FMB230 Product Change Notifications

[Main Page](#) > [Advanced Trackers](#) > [FMB230](#) > **FMB230 Product Change Notifications**

2024.01.22: Modified battery placement within the casing

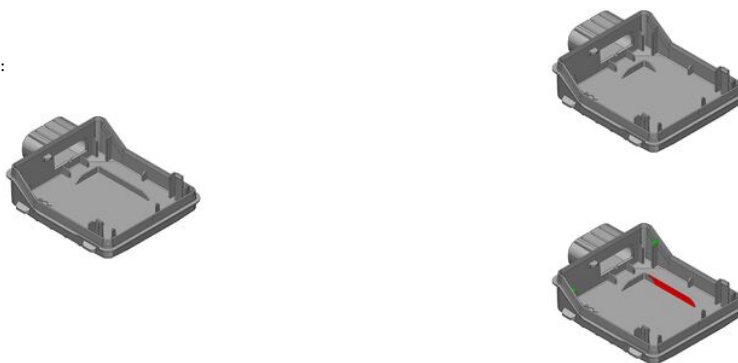
We would like to inform you that starting from January 2024, there will be a small change in the FMB230 devices casing. We have adjusted the battery placement and increased PCB guide height within casing. This modification was essential to enhance our manufacturing process.

Change reasons 1. Modified battery placement within the casing.
 2. PCB guide height increased for easier assembly.
 3. Improved manufacturing process.
